REPORT ON CABLE INSTALLATION

MIDLAND PLANT UNITS 1 AND 2

BECHTEL POWER CORPORATION

REPORT ON CABLE INSTALLATION  
MIDLAND PLANT UNITS 1 AND 2

SK-4

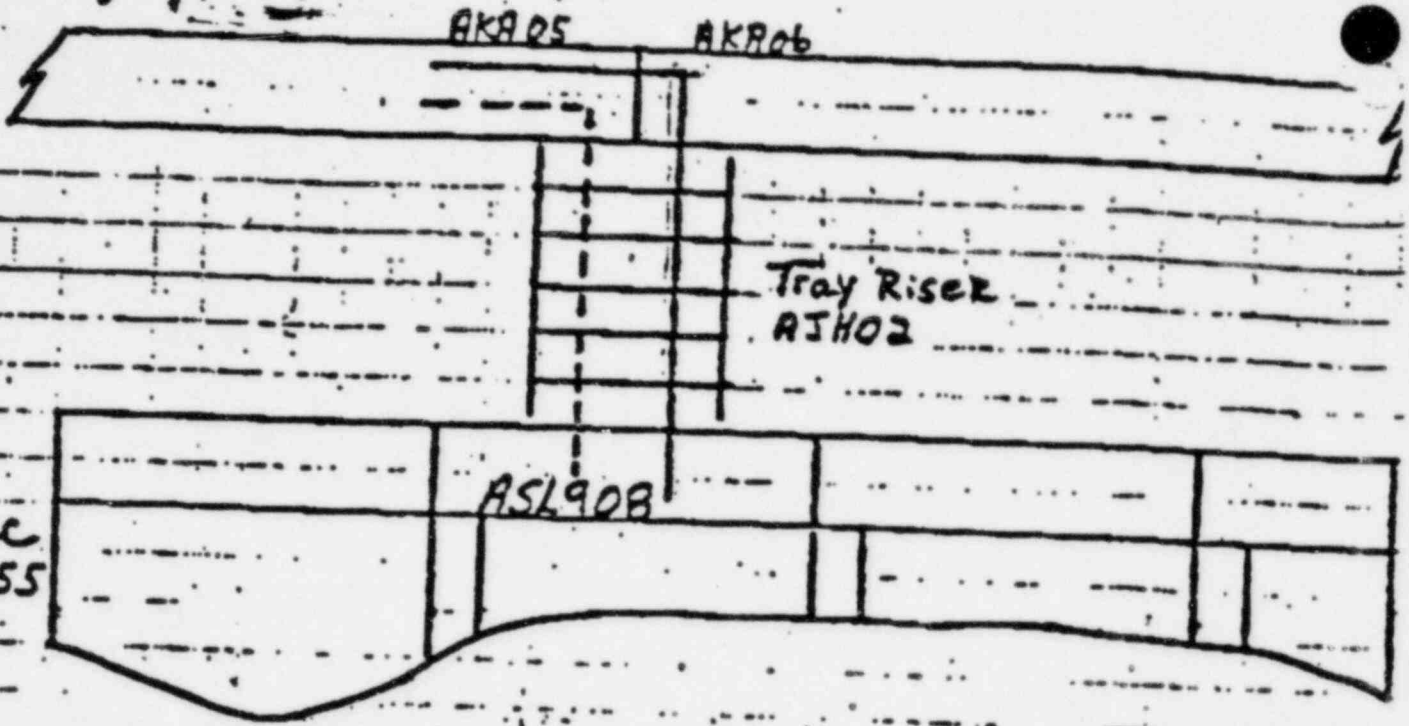
The subject cable enters the confines of an additional raceway. If the trays containing subject cable were required to be wrapped, how do we make sure that the cable is protected.

SK-5-A  
Midland Plant Units 1 and 2  
Attachment 3 to  
Report on Cable Installation

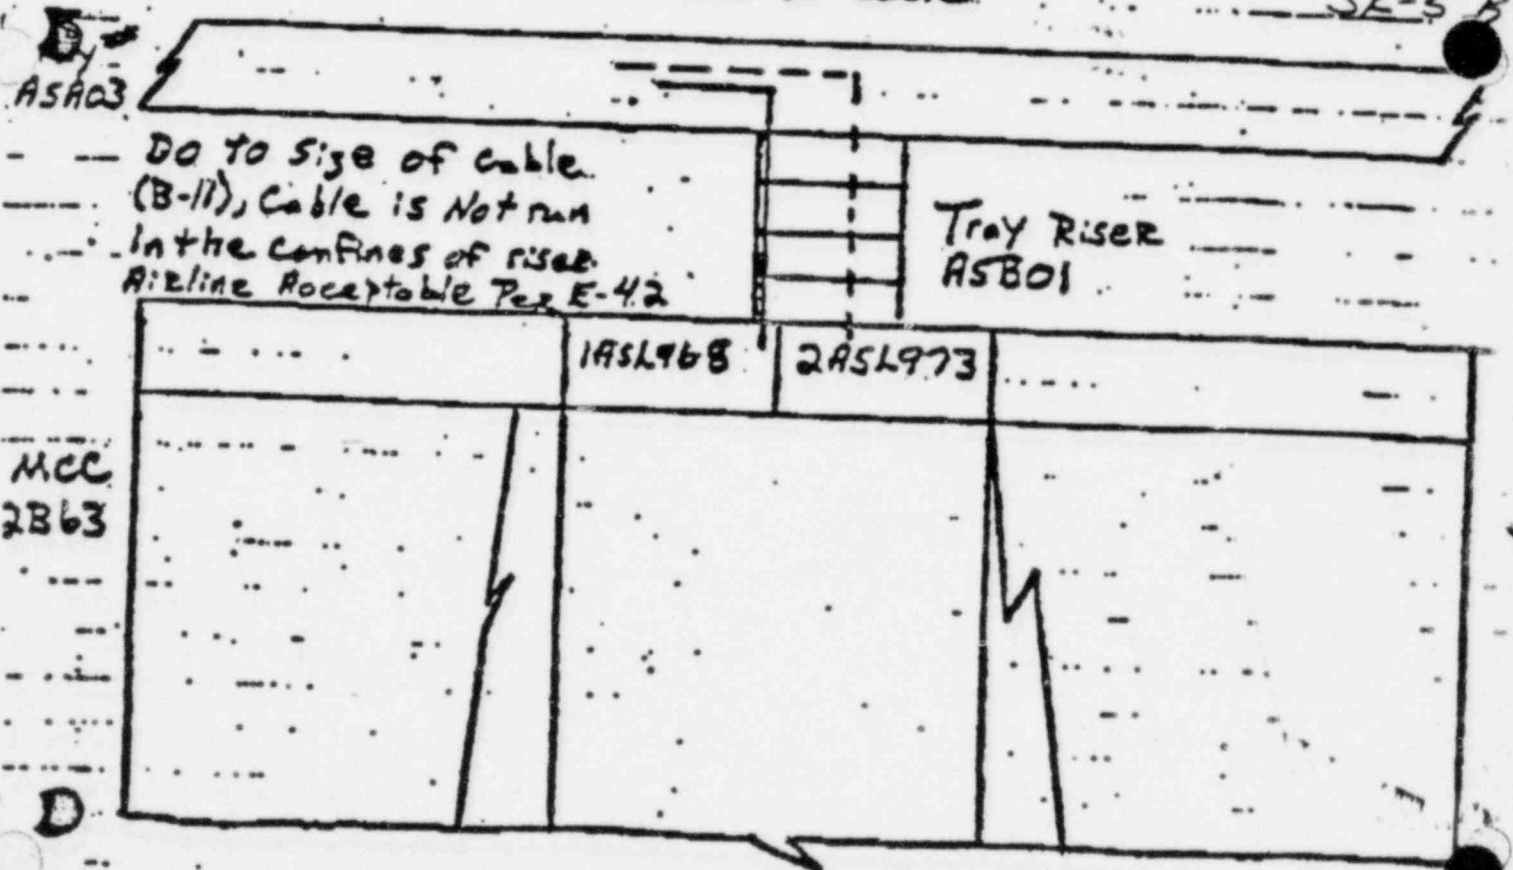
Cable is routed-by field  
Cable should be routed-per E-37

A cable can be airlined 3 feet without engineering approval. The cable enters the correct stack (the subject stack of this MCC has two slot numbers; i.e., one opening, two numbers).

1BBS605B SK-10  
Midland Plant Units 1 and 2  
Attachment 3 to  
Report on Cable Installation  
Tray Riser BJH04  
Tray Riser BJH06

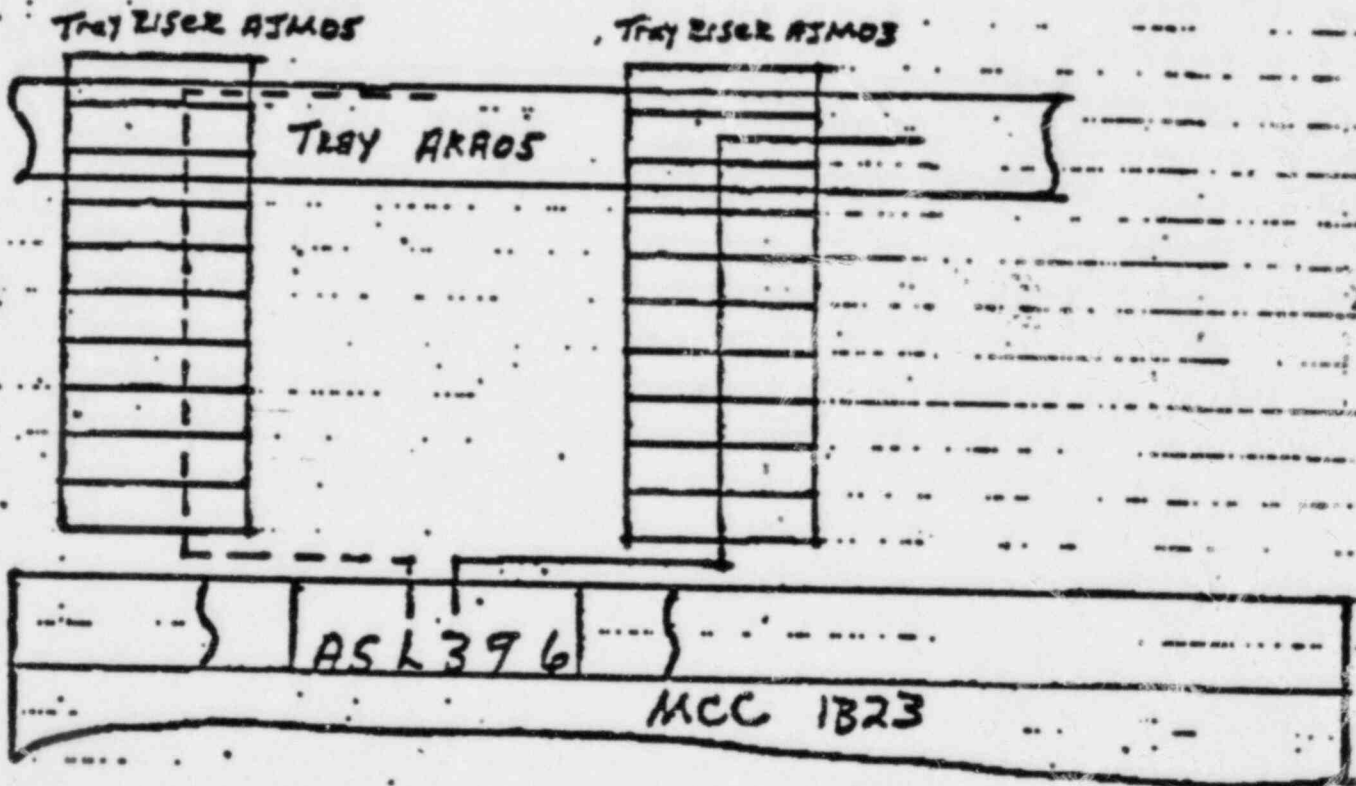
Cables are airlined, and are not in the riser.

A cable can be airlined 3 feet without engineering approval.

SK.12

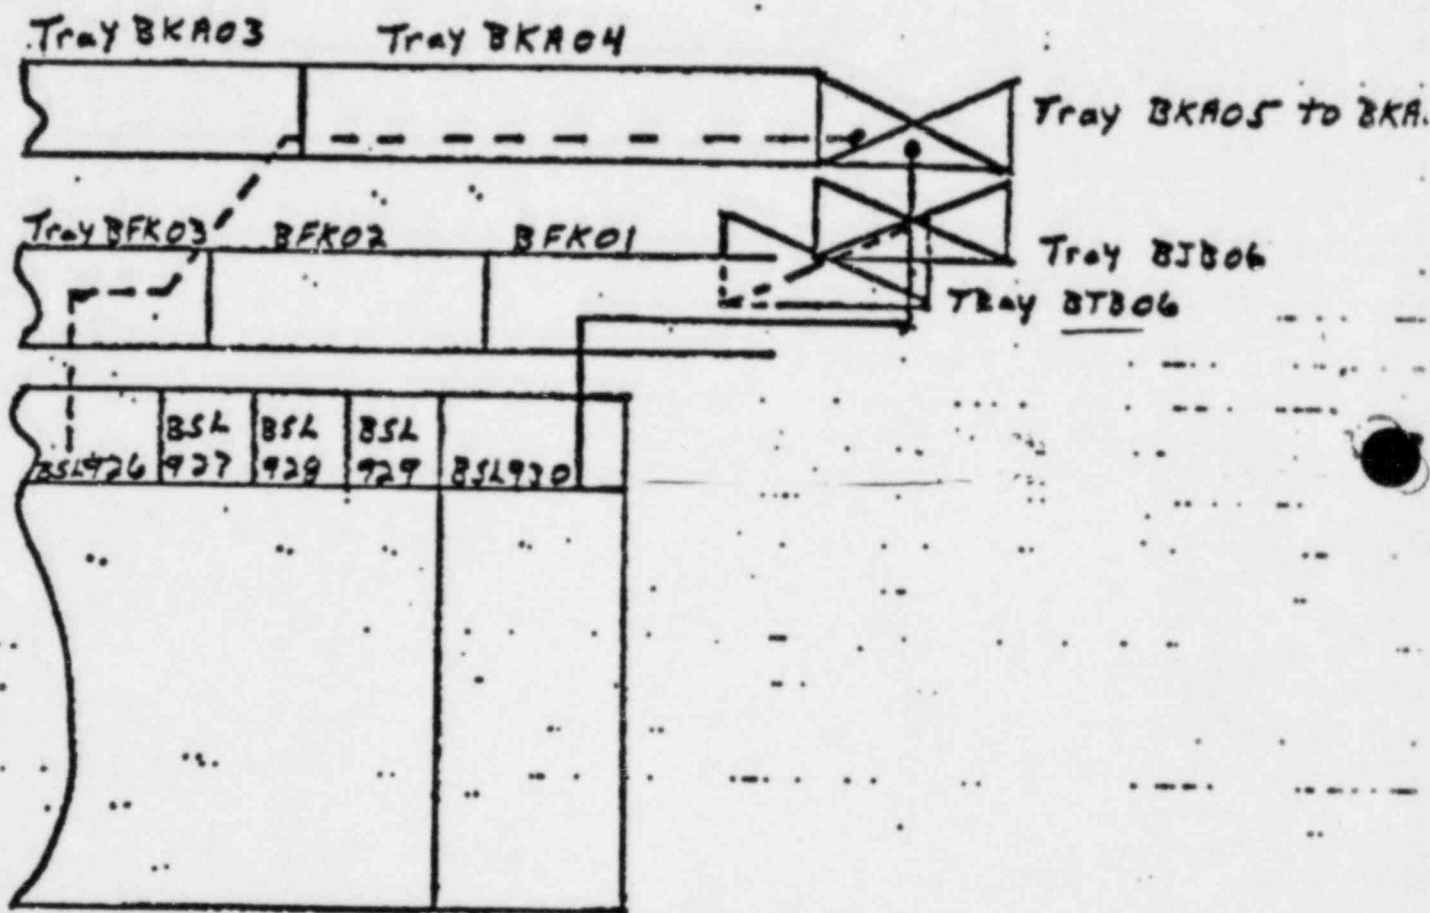
Cable is Routed - by field

Quality control will inspect all cable transitions from one raceway to another; this inspection will eliminate this concern.

SK-14

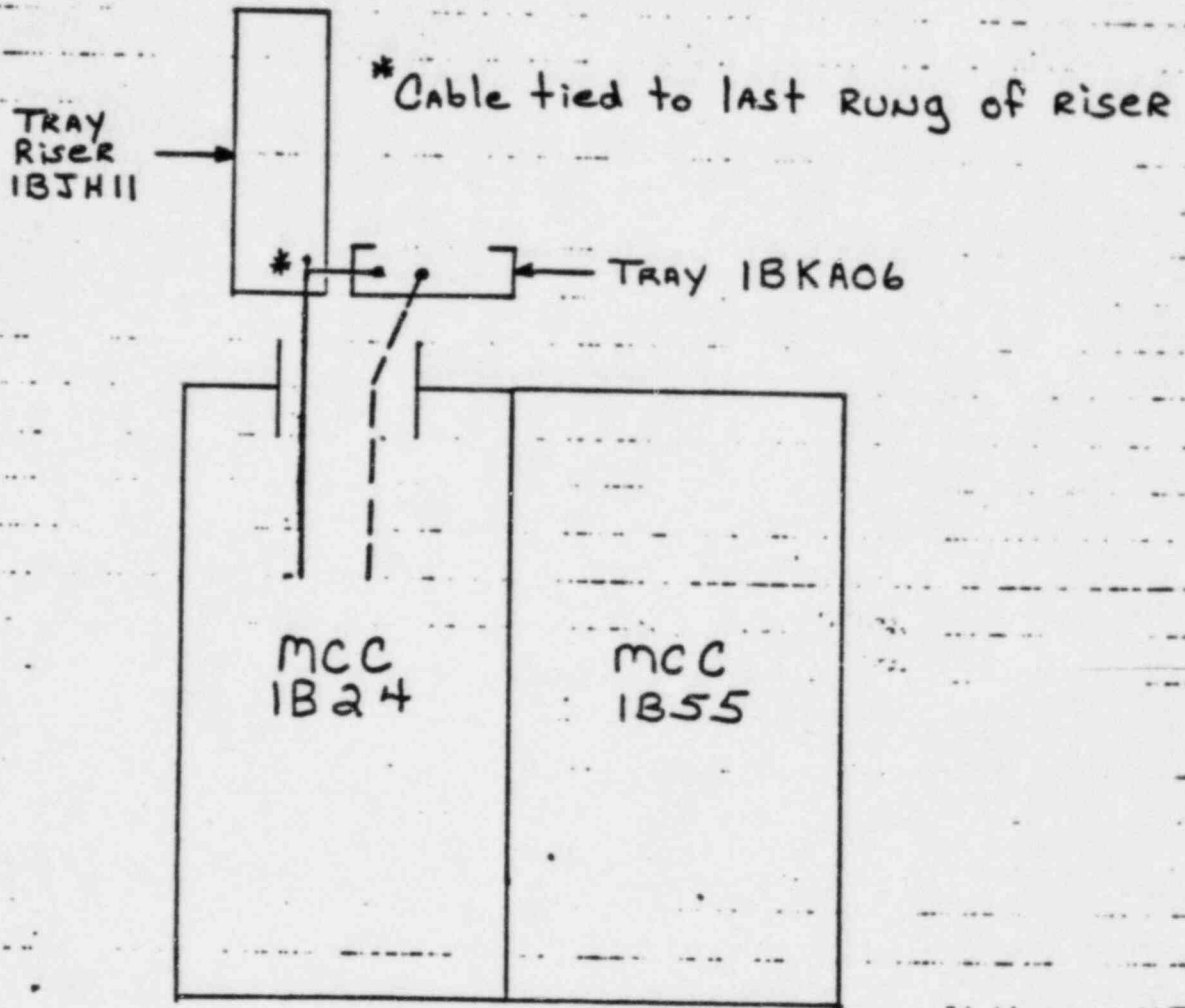
The subject cable enters the confines of additional raceway. If the trays containing the subject cable were required to be wrapped, how do we make sure that the cable portion in the unlisted via is protected.

SK # 15.  
Midland Plant Units 1 and 2  
Attachment 3 to  
Report on Cable Installation

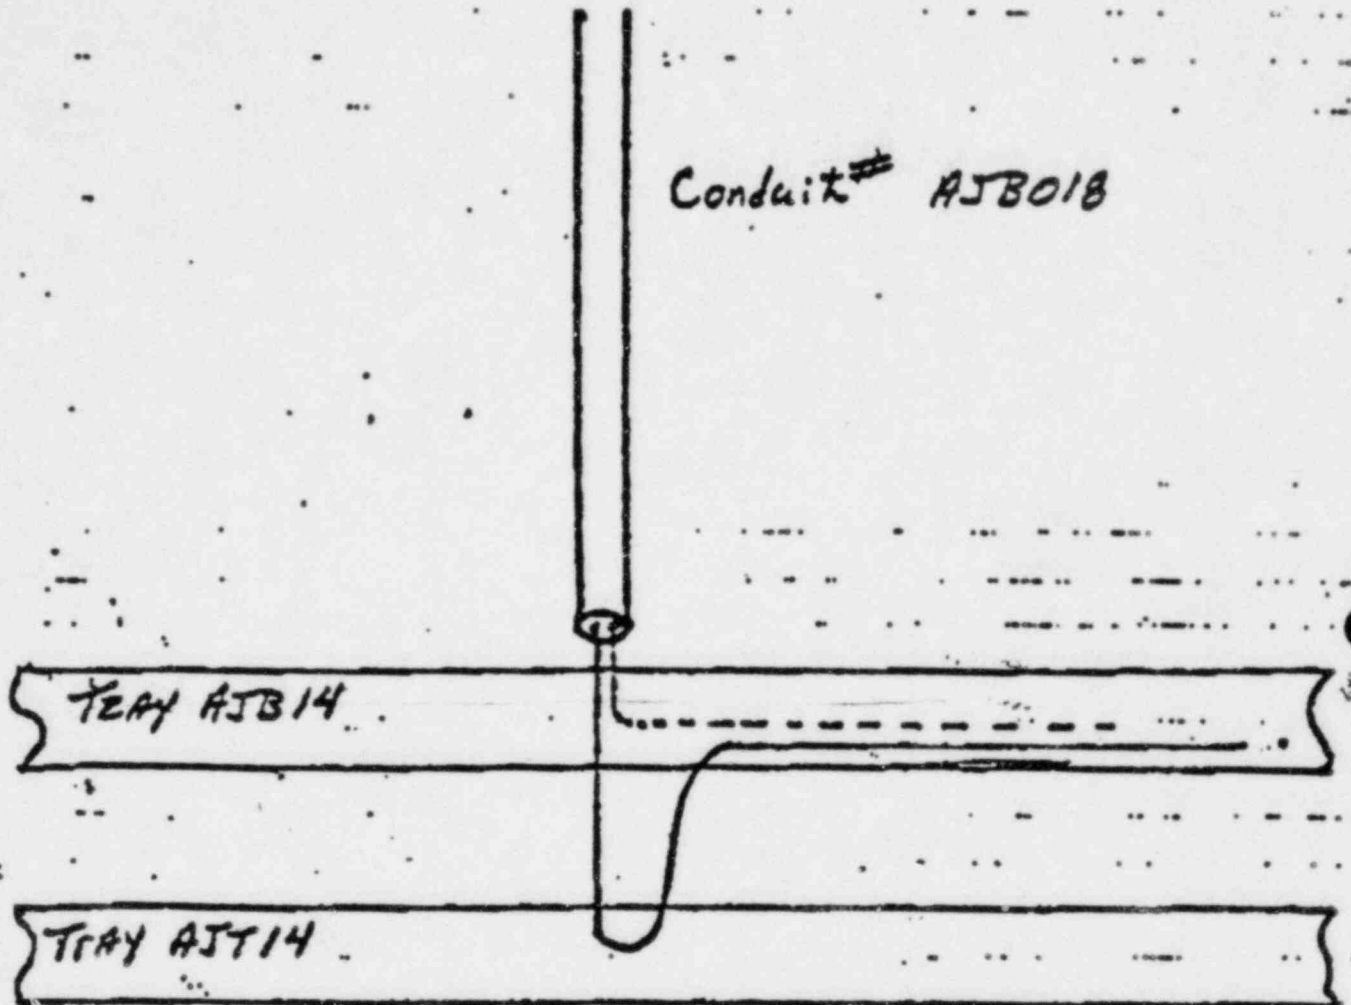
Cable is pulled into BJH11 which was not one of its assigned  
vias.

The cable is only tied to the last rung of the riser, and will  
not contribute to thermal loading of the riser.

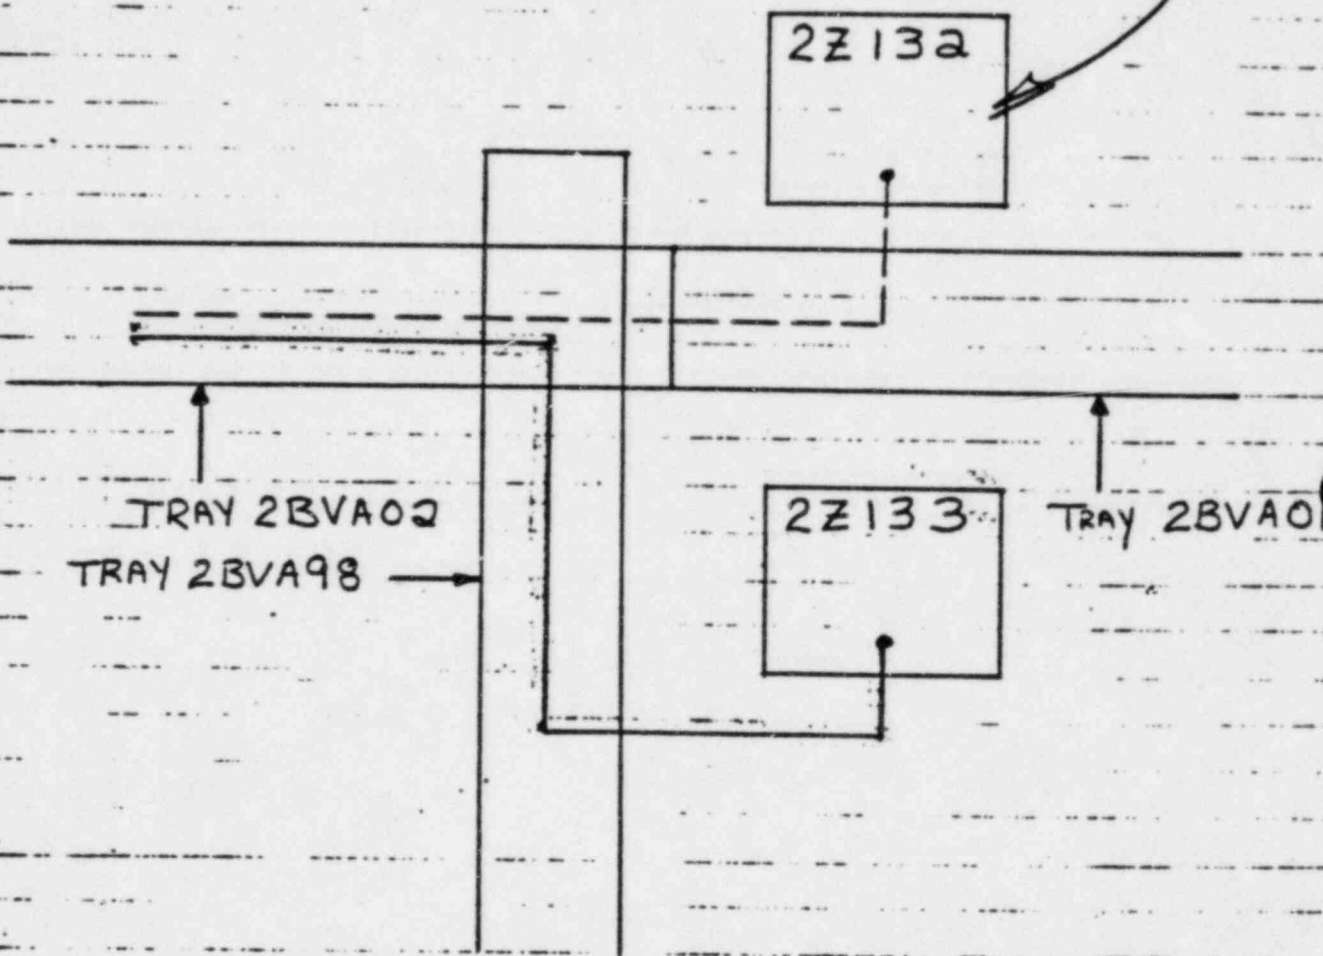
Cables looped out the bottom of tray AJB14 into tray AJT14.

As a normal procedure, construction eliminates all slack from cables before tying them down. With this procedure accomplished, this concern will not be a problem.

SK.19

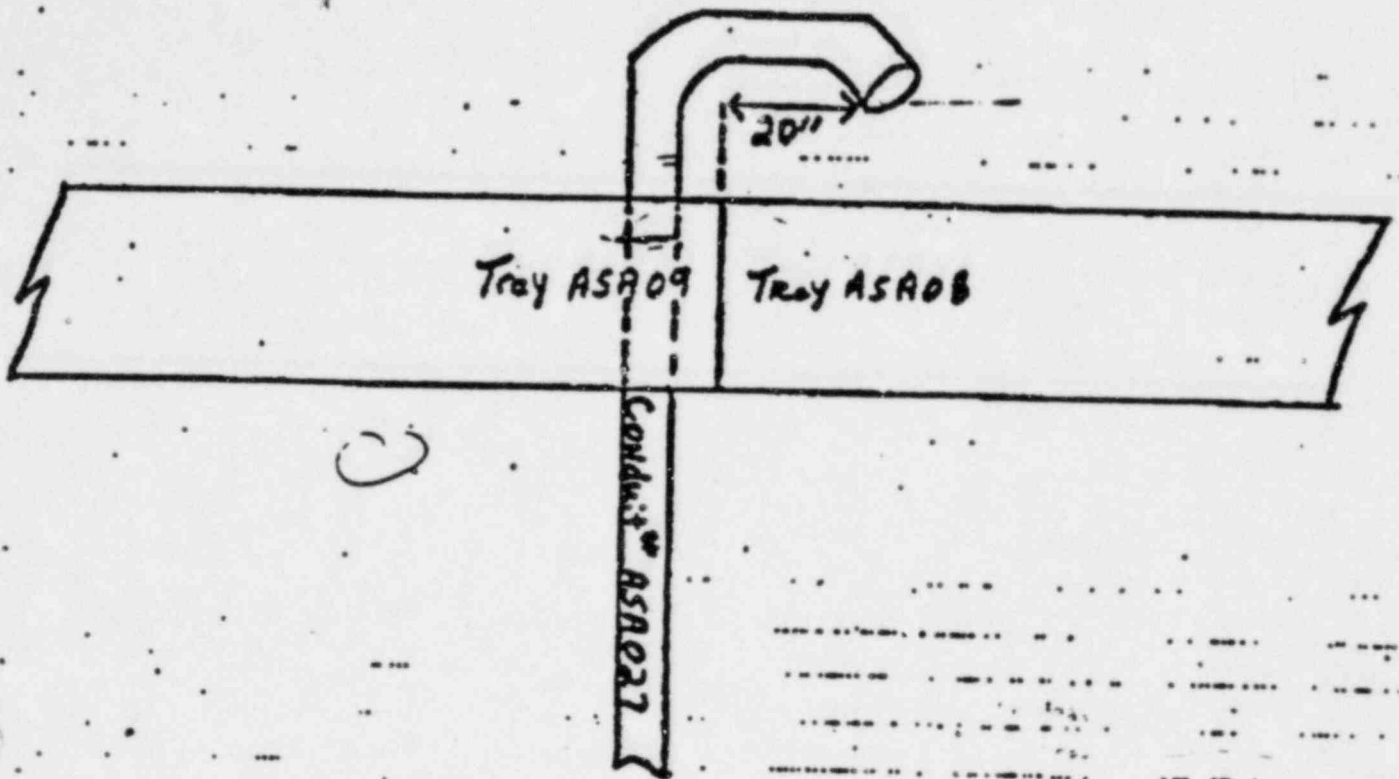
CONDUIT # ASA027 installed at incorrect END location.  
Should run to ASA09 ± 18" into adjoining tray section.  
Cable vias per K-37 are: ASA027 ASA09 ASA08  
Due to incorrect END location: ASA027 — ASA08

The actual cable installation did not use all the designed raceway vias. Therefore, the absence of a cable would only make thermal analysis more conservative.
